Appendix 1 "CROQUIS"

Source: Dossier d'examen interne (DEI) of file P-110-3461.

This file led to the decision and order of April 30, 2021 (D-2021-056). HQ sent the DEI to the Régie on Dec. 14, 2020. Footnote 10 of decision points to further details, including following:

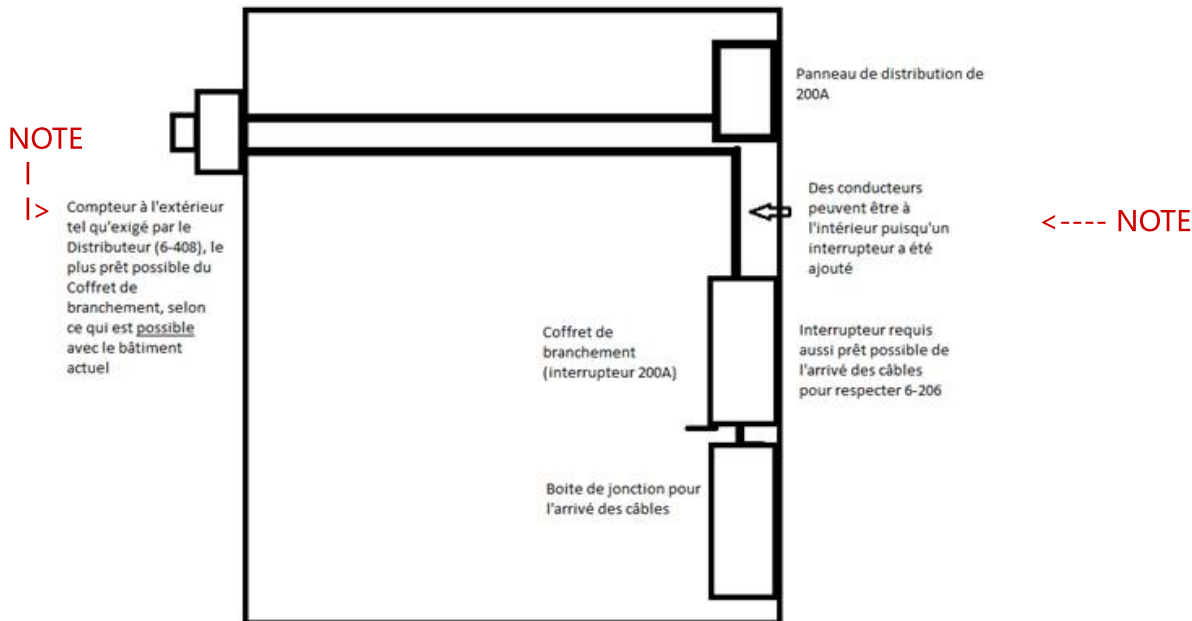
J'ai fait un petit croquis indiquant les articles mentionnés du Code.

C'est conforme avec le Code s'il ajoute un interrupteur 200 A, c'est souvent ce qui est mal compris.

The space represents the garage integrated within the left side of my home. The garage door is towards the bottom and service arrives by underground conduit. The house is on a corner lot. An upgrade of 100 to 200 amps was needed for conversion from oil to electric heat. The proposal by HQ was to move the meter from right (indoor location), to left (outdoor location with 200-amp wiring through conduits on ceiling as opposed to being buried under concrete slab).
